NOTICE OF VIOLATION

On May 6 and 7, 2025, Energy Safety conducted an inspection of SCE's WMP initiatives in the vicinity of the city of Moreno Valley, California. The inspection report is enclosed herewith. Energy Safety found the following violation(s):

INSPECTION REPORT

Violation 3

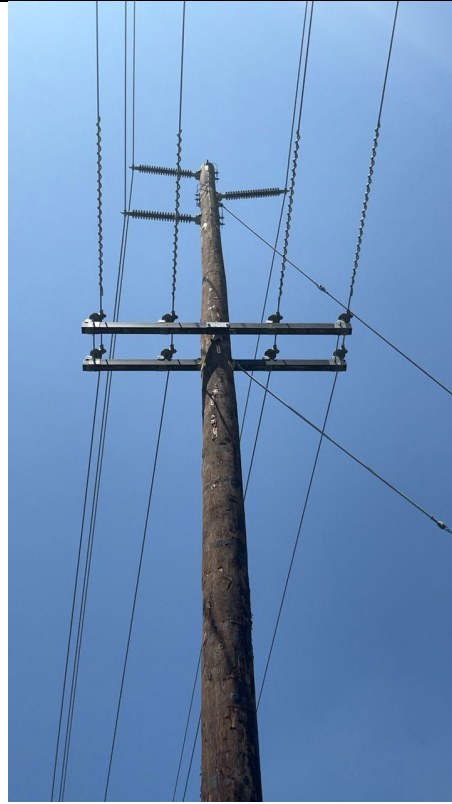
On pole ID 4491275E, Grid Hardening ID 410903702-4491275E at 34574-34810 Gilman Springs Rd, Moreno Valley, CA, 92555, USA, 33.8807560895587, -117.057891499872, the inspector observed that no wildlife covers were installed. The inspector's observation is documented in Violation 3 photographs, which are attachments to this report. Photo numbers Item3IA1Img1 and Item3IA1Img2 depict that there are no wildlife covers on the pole. Per information provided by SCE to the Compliance Inbox on June 4, 2025, at 4:13 pm, the remediation of wildlife covers was completed.

1. Southern California Edison Company's 2024 WMP 8.1.3.1 Distribution Detailed Inspections and Remediations work identified that the remediation of wildlife covers was complete at this location.
2. The wildlife covers were not installed.

Item3IA1Img1: View showing no wildlife covers installed

Item3IA1Img2: View showing no wildlife covers installed
